SECTION 23
T19 S. R41 E. W.M.

Vale Oregon
Irrigation
District

HB 3111 Petition			
Page	of	Pages	
Digitized By	RJ & LHP	Approved

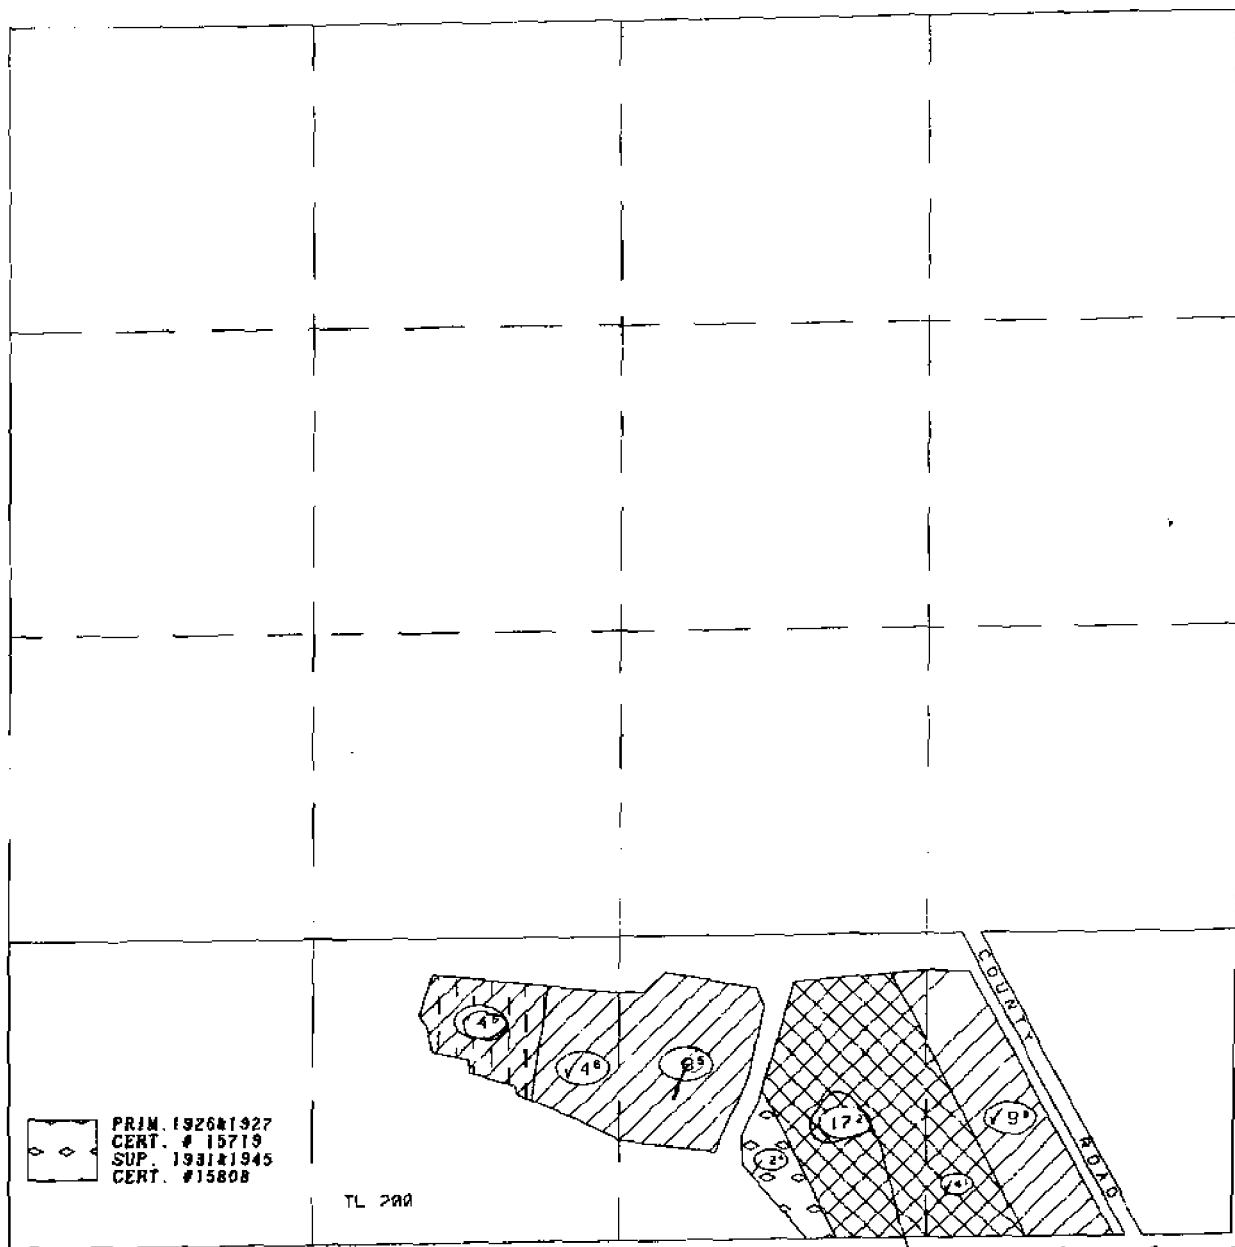
Should this be 14.8 ac?
